Summary note in support of non-material amendment to approved planning application 22/07046/FU, outlining changes to the approved design

Proposed East Elevation

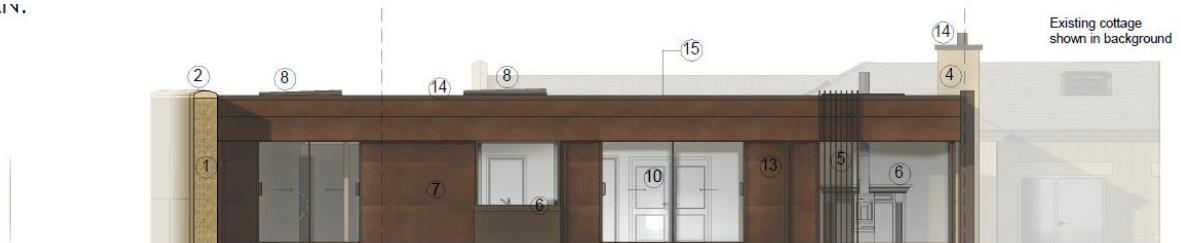
1. Re-positioning and re-sizing of windows and french doors to the East elevation (front of the property), and a re-positioning of the front door.

Proposed South Elevation
1 : 100

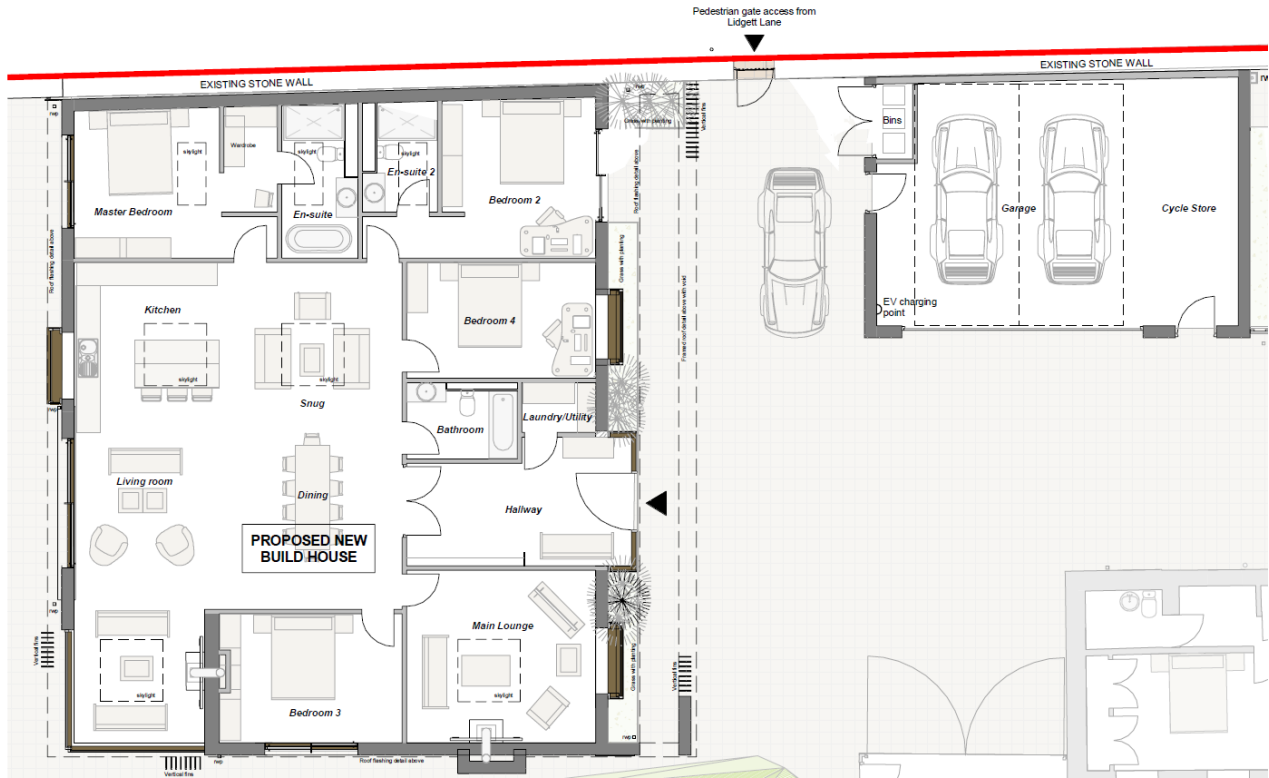
3. Update to the window layout of the South elevation (side of the property), and changes to materials for garage doors.

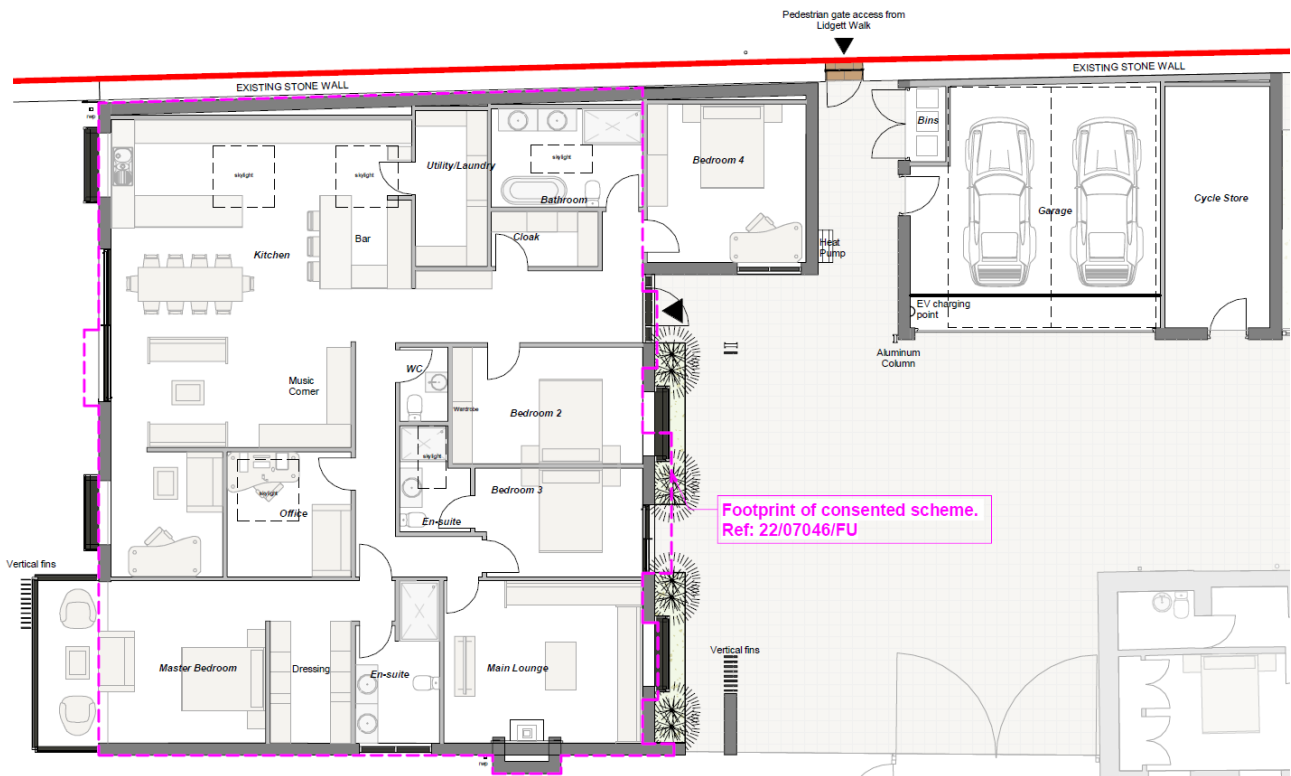
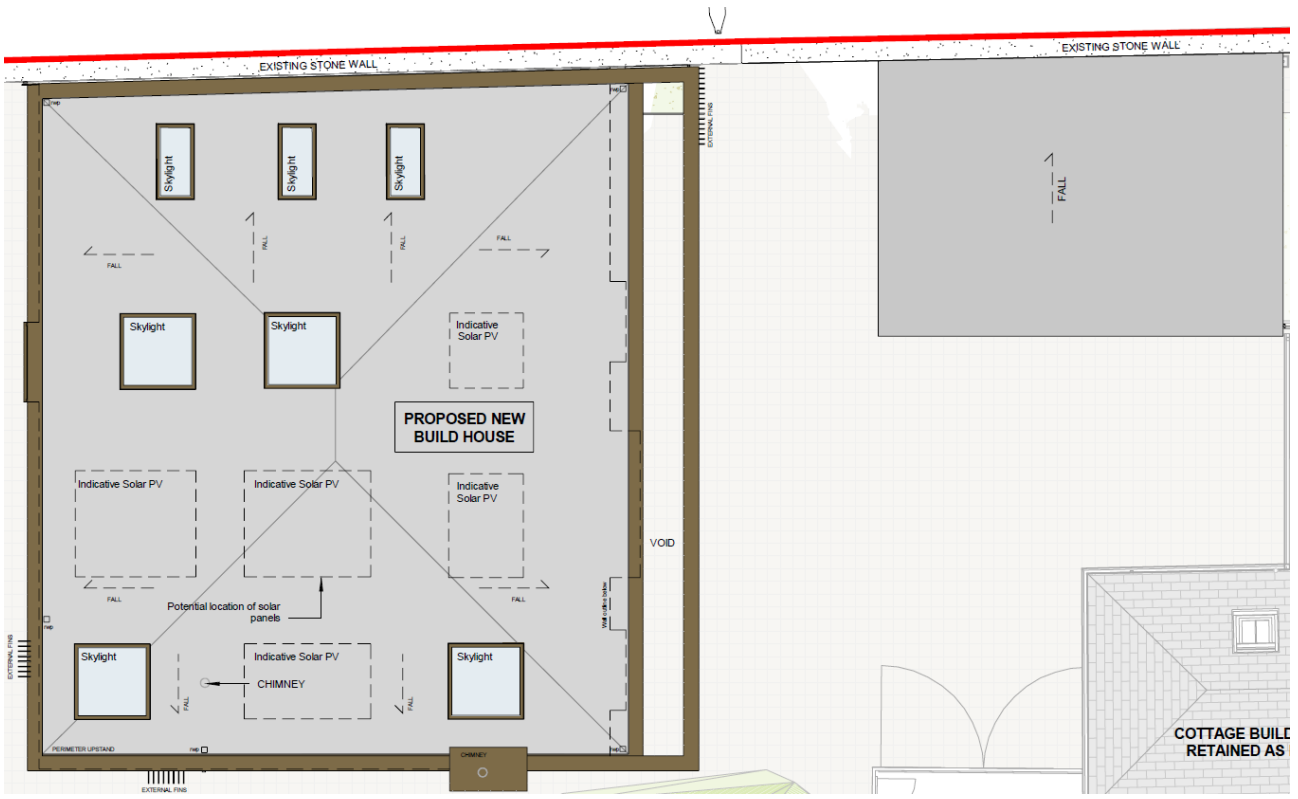
- Minor re-design of building footprint as shown dotted in magenta below. Interior layout reconfiguration with re-positioned exterior windows / doors to support this. Re-location of pedestrian gate slightly to the east.

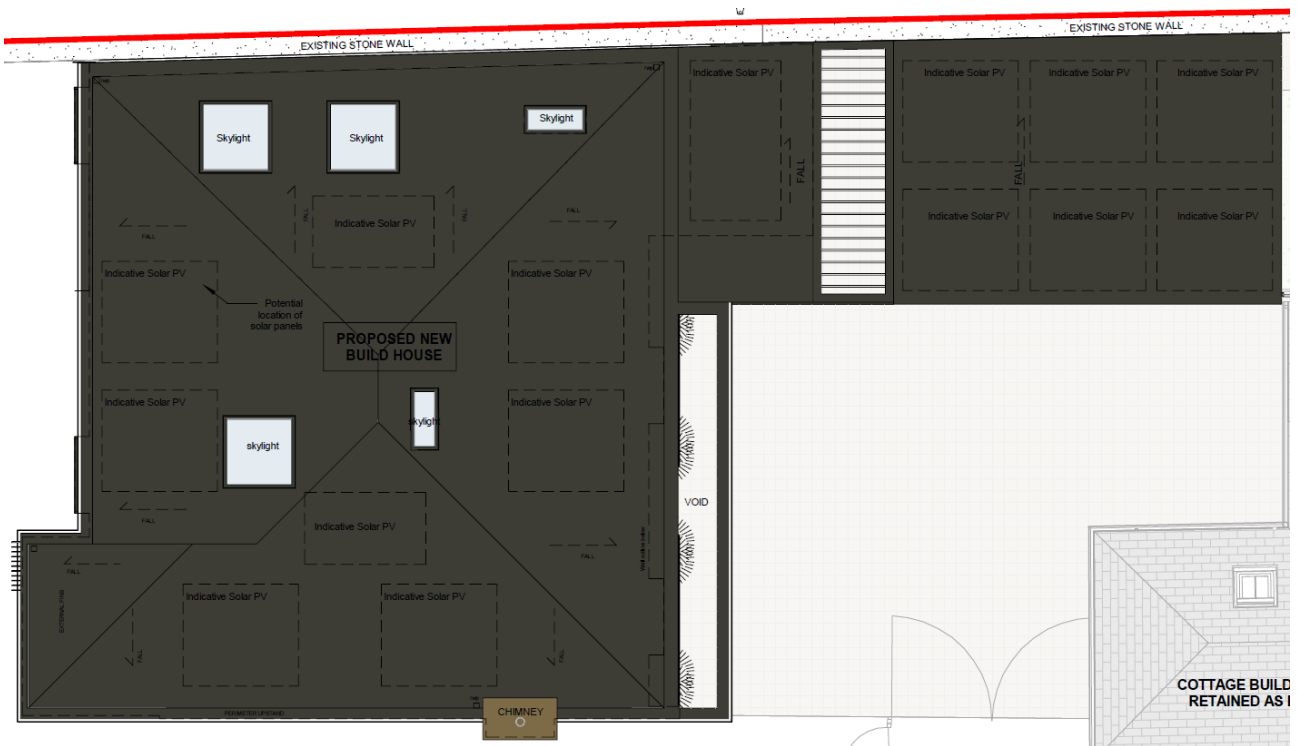
- 5. Updated roof plan, connecting the house to the garage for enhanced amenity / aesthetic and to allow for an extended solar panel plan. Updated skylight layout in support of the updated interior layout.
